**Rezoning Transportation Analysis**  
**Petition Number: Insert Zoning Petition #2021-214**  
*General Location Identifier: 11123345*

**Revision Log:**

Date	Description
01-21-2022	First Review (AO)
02-24-2022	Second Review (AO)

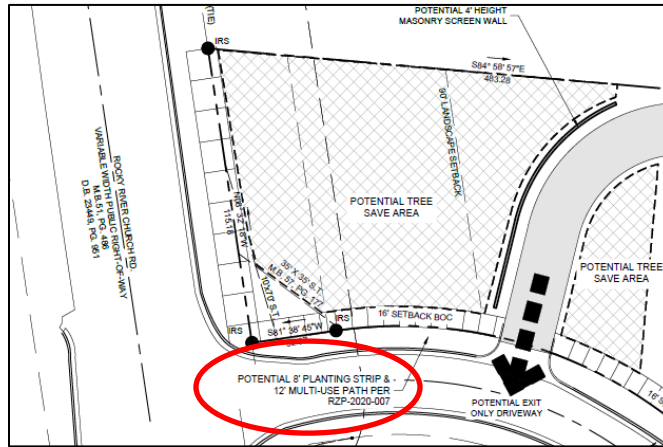
1. ~~**Curblines:** The proposed zoning district has a setback measured from back of the existing or proposed future curblines.~~
  - a. ~~**Rocky River Road:** Location of curb and gutter is in its existing location.~~
  - b. ~~**Woodland Beaver Road:** Location of curb and gutter is in its existing location.~~

~~Label and dimension the curb and gutter from the centerline for each road on the site plan.~~

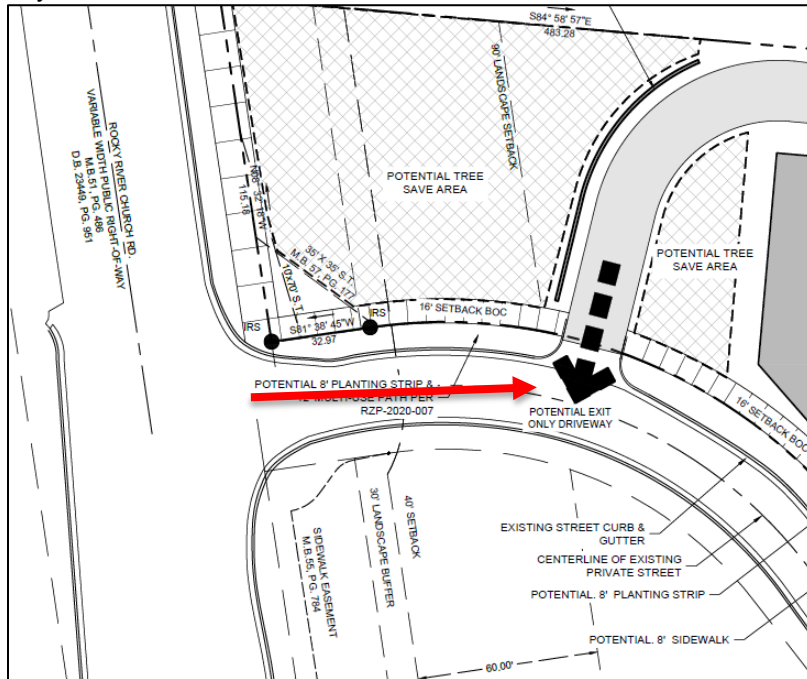
4. ~~Resolved (New Site Plan, 2-14-22):~~ Revise site plan and conditional notes showing a minimum of 100' of separation from proposed egress access point of Woodland Beaver Road measured from right of way line from Rocky River Church Road.

Label and dimension from right of way line along Rocky River Church Road.
